SERVICE BULLETIN

B-075

Safety Recall Code 0834

2008 1125R TRANSMISSION JET RECALL

Figure 2. Oil jet kit

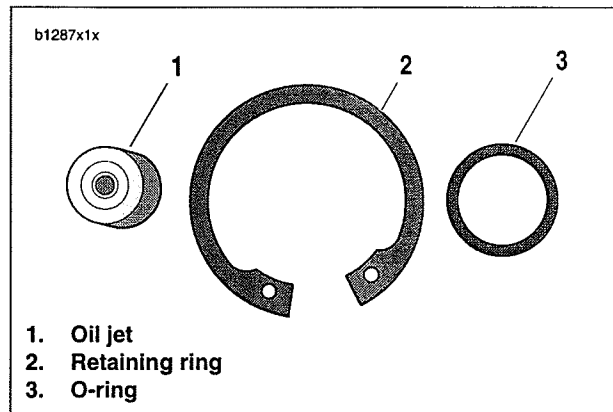
**Table 1. Safety Recall Code 0834
Kit 94678Y Contents (see Figure 2)**

Quantity	Part No.	DESCRIPTION
1	Q0094.1AM	Oil jet
1	CE0010.1AM	Retaining ring
1	CF0023.1AM	O-ring

See Figure 2. The retaining ring (2) holds the actuator piston in place to prevent spilling of clutch fluid.

Figure 10. Oil Jet

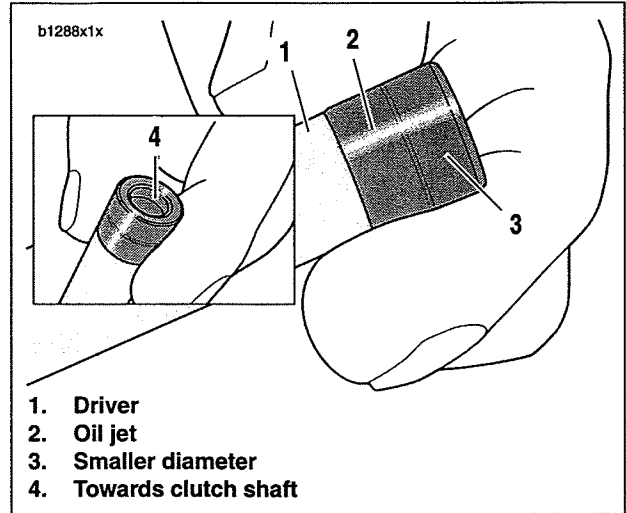
- See Figure 10. Apply 2-3 drops of LOCTITE 648 (green) or equivalent onto the smaller outside diameter (3) of the oil jet.

See Figure 10. To install oil jet (2), use a driver (1) that has a larger diameter than the oil jet. The smaller diameter (3) of oil jet faces clutch shaft.

Figure 12. Installed Oil Jet

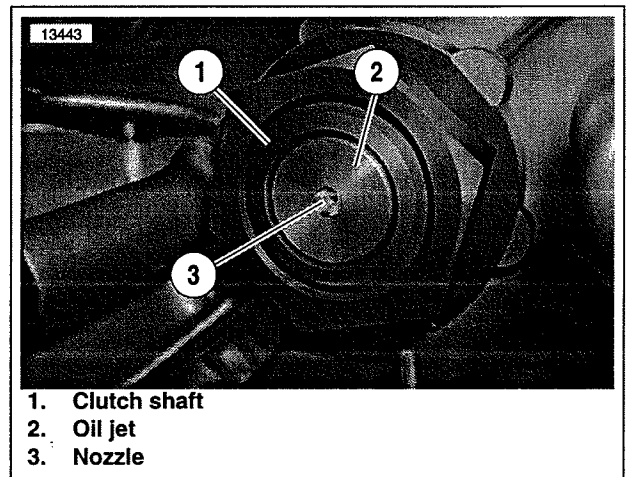
See Figure 12. If oil jet has already been installed as a result of efforts by Buell Racing Support, proceed to step 18.

- See Figure 12. Install oil jet (2) into clutch shaft (1) until oil jet is flush with end of clutch shaft.
- Clean oil jet with compressed air and make sure nozzle (3) is not blocked.
- See Figure 13. Fit the stepped washers and fasteners to the springs and install the pressure plate and springs.
- Install the springs in a cross pattern until the fasteners bottom
- Tighten the fasteners to 89 in-lbs (10 Nm).
- See Figure 14. Verify that the two needle pins (1) are in place in the clutch cover.
- Install the diaphragm cover gasket (2).
- See Figure 7. Apply LUBRIPLATE No. 105 Motor Assembly Grease to the bore of the inner clutch diaphragm cover (2).
- Fit the diaphragm cover with the embossed BUELL side out.
- Install inner disc plate (1) with side stamped "OUT" facing away from engine.
